THE HOTEL AT FOUNDRY PLACE, "LOT 3": 165 DEER STREET, ASSESSORS MAP 125 LOT 17, AND RELATED IMPROVEMENTS TO LOTS 2, 4 & 5

SITE PLAN REVIEW

SITE PLAN REVIEW
FEBRUARY 6, 2018

DEVELOPMENT INCENTIVES PLAN

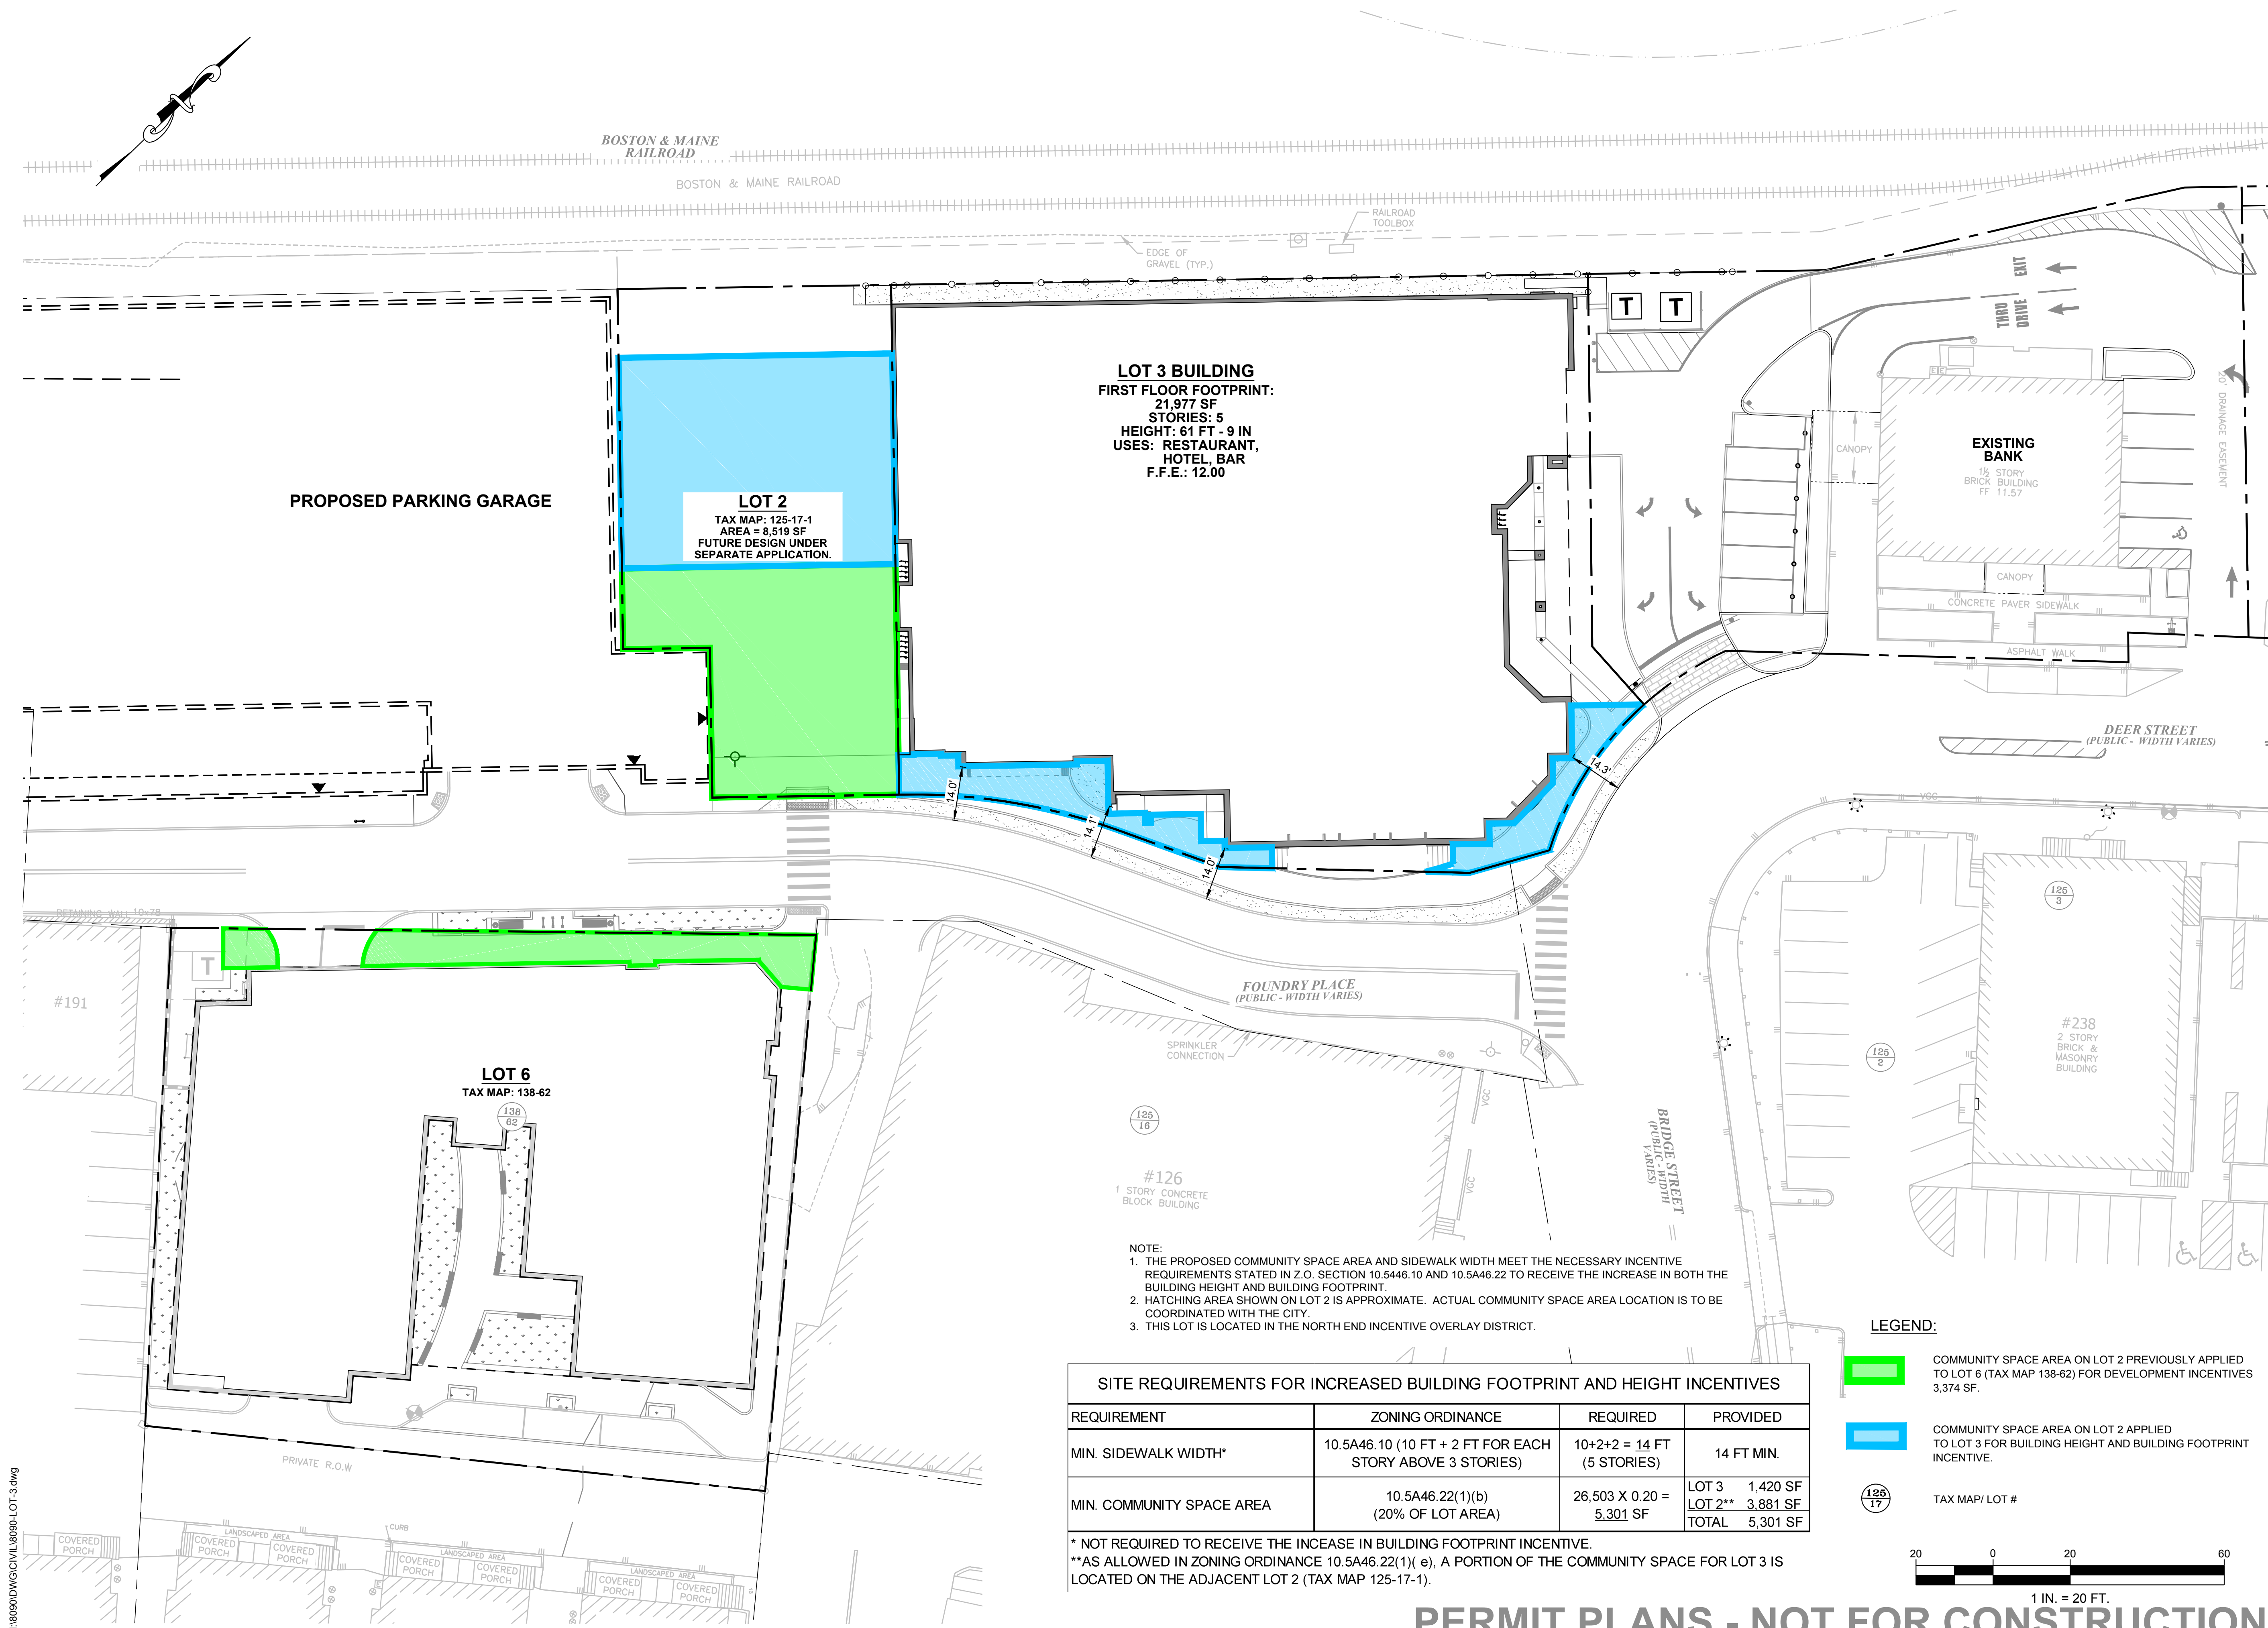
Geolinsight's previous and current drawing (Sheet C3.4) that addresses Community Space identifies what areas of the Foundry Place, LLC Lot 2 property were utilized by DSA for Lot 6 and will be utilized by Foundry Place, LLC for Lot 3. Because Lot 3 and Lot 6 will be counting some of the Lot 2 space toward development incentives, a formal arrangement is necessary to keep the Lot 2 area as Community Space in the future. With regard to the remaining space on Lot 2 that has not yet been appropriated for other future incentives, Foundry Place expects to reserve the right to use the space for future incentives or assign that right to DSA. However, the entirety of Lot 2 is still planned to be transferred to the City by Foundry Place, LLC at the end of the development process, whether there is unencumbered space remaining on Lot 2 at the time of the transfer or not.

**UTILITY PLAN -
WATER, GAS, &
ELECTRICAL**

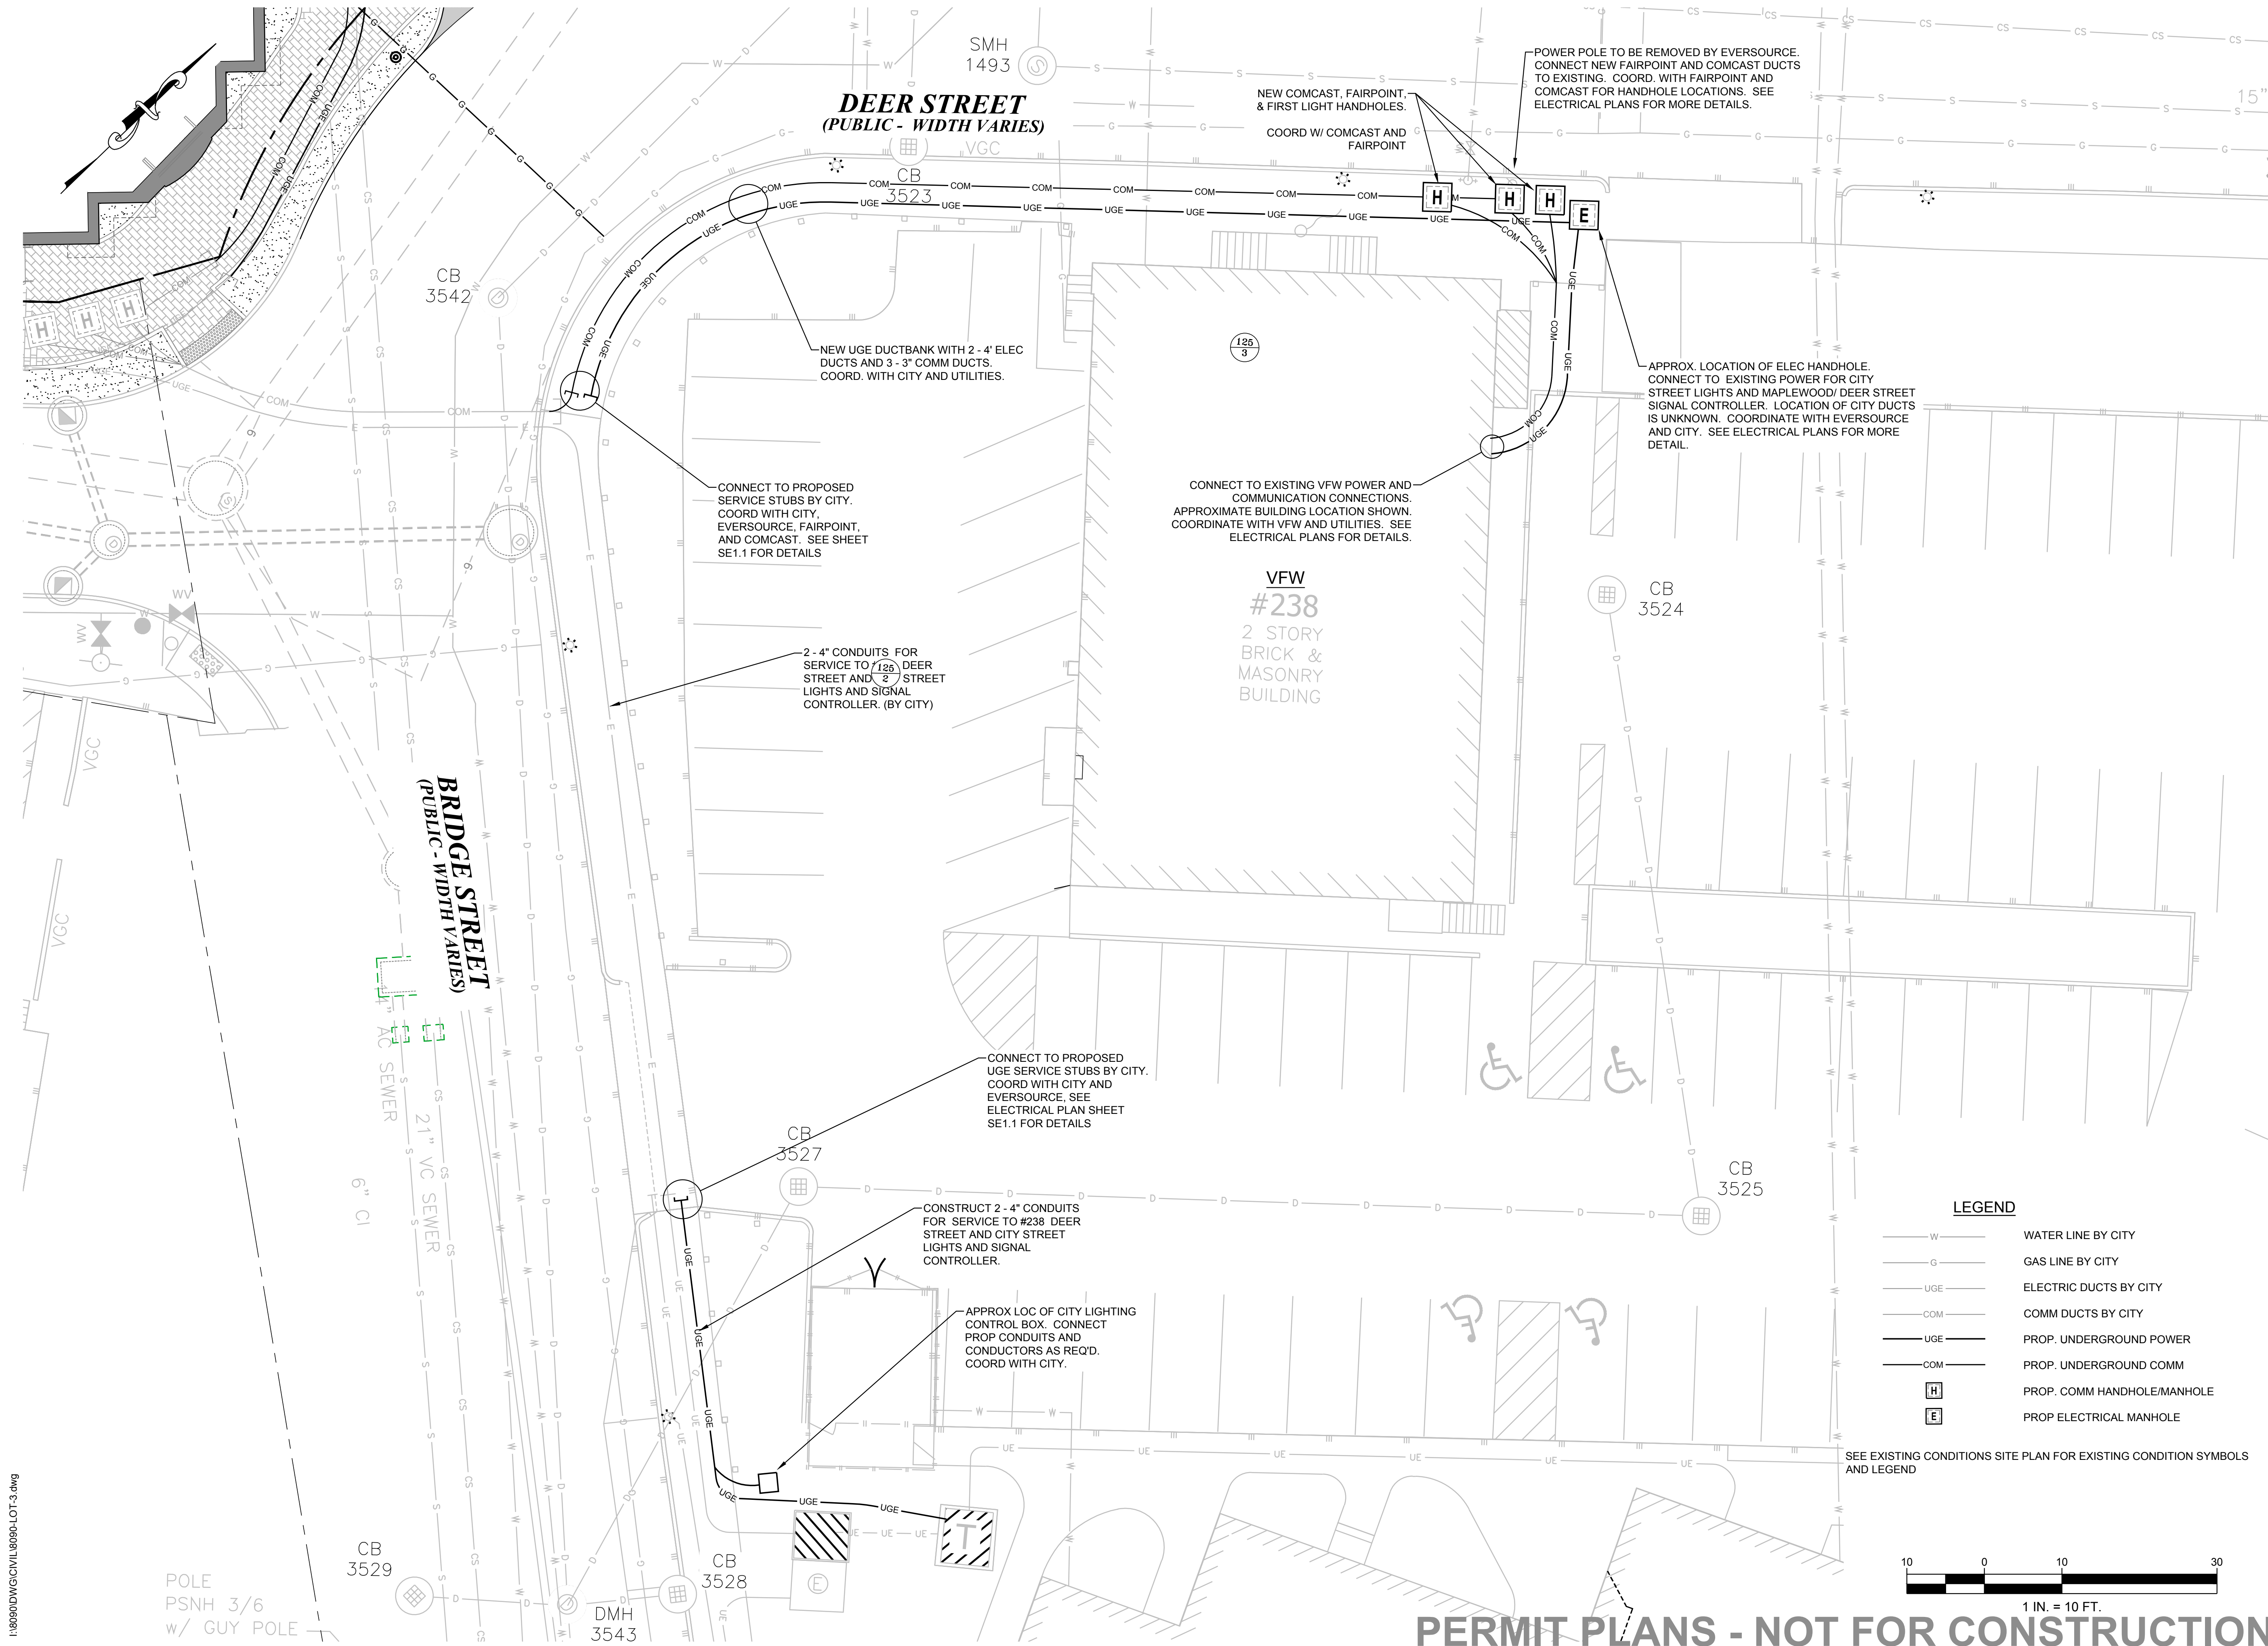
We have reviewed sheets C5.1 and C5.2 of the Site Plan title The Hotel at Foundry Place, "Lot 3", 165 Deer Street, Assessors Map 125 Lot 17 plan set with revision date of 11/17/2017. Comcast gives preliminary approval of the conduit layout and will serve the property upon request.

Re: Approval of the proposed gas layout as shown on Sheet C5.1 of *The Hotel at Foundry Place, "Lot 3"...* plan set with revision date of 11/17/2017
